# **Darwin Pipeline Duplication Project**

*Submission to the Northern Territory Environmental  
Protection Authority*

**June 2023**

**Figure 1: The Proposed Bayu-Undan CCS Project**

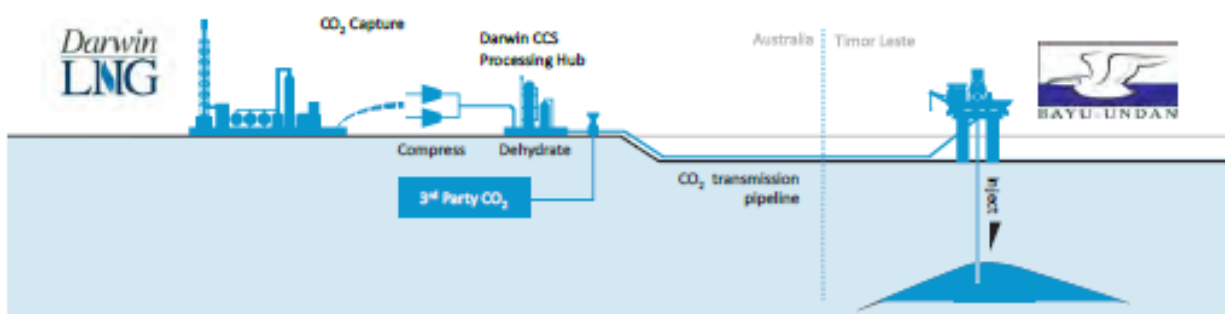
4. How would the Bayu-Undan reinjection facility be powered since that function will replace gas production? There have been suggestions that diesel may be shipped out to Bayu-Undan to provide the required fuel. A large storage tank might be required on the platform that will sit above the Bayu-Undan field (Figure 1), and the constant fuel consumption to operate the CO<sub>2</sub> reinjection process. This is in addition to the life-cycle emissions from ferrying workers to and from the platform from the mainland by helicopter, and their energy consumption while working on the platform. These extra emissions that must be estimated and publicly declared before approval can be considered. Santos needs to detail how the CO<sub>2</sub> will be injected into the Bayu-Undan reservoir and what infrastructure will be installed at Bayu-Undan to inject the CO<sub>2</sub> into the reservoir.

**Figure 2: Barossa Gas to Darwin LNG Project Emissions per Offshore Processing Platform**

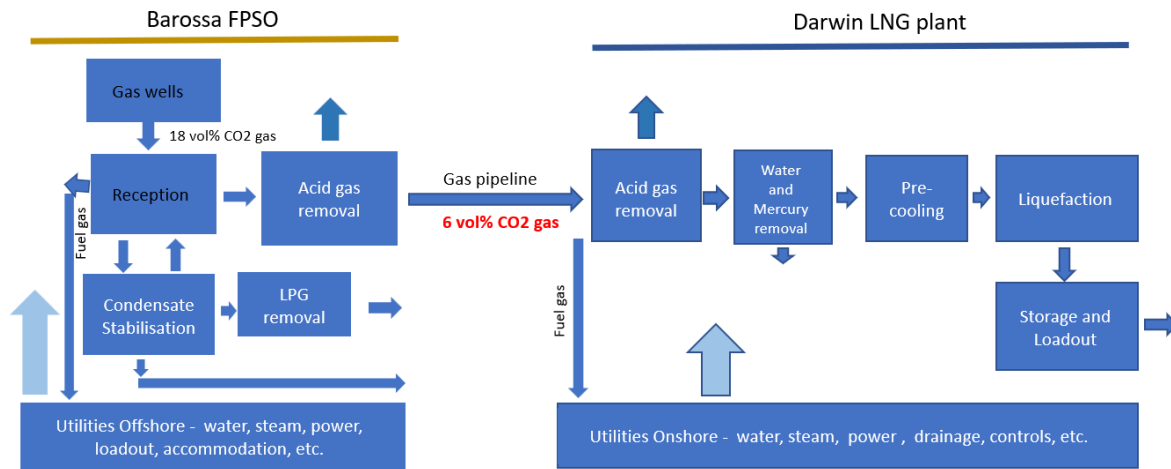
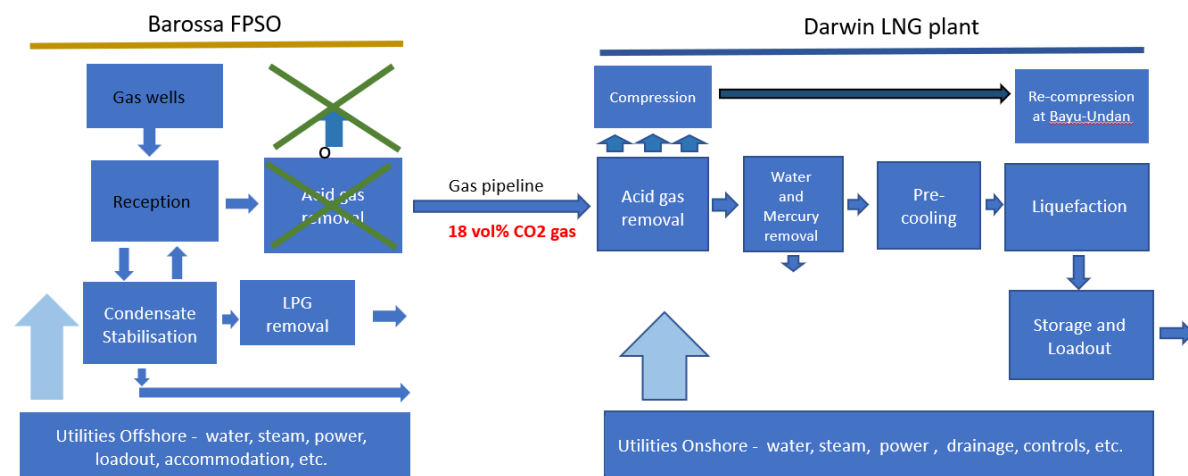
6. Santos is working towards an unapproved scheme for the acid separation activities at the Darwin LNG liquefaction plant (Figures 2, 3). The implications of moving 18% CO<sub>2</sub> from Bayu-Undan rather than 6% CO<sub>2</sub> from the Bayu-Undan field, as per the National Offshore Petroleum Safety and Environmental Management Authority (NOPSEMA) approved offshore project proposals (OPP) in March 2018,<sup>9</sup> are very significant in terms of emissions offshore at the Barossa floating production storage and offloading (FPSO) facility and onshore at the Darwin LNG liquefaction plant, and must be considered along with the timings of various parts of this now most complex of LNG projects.
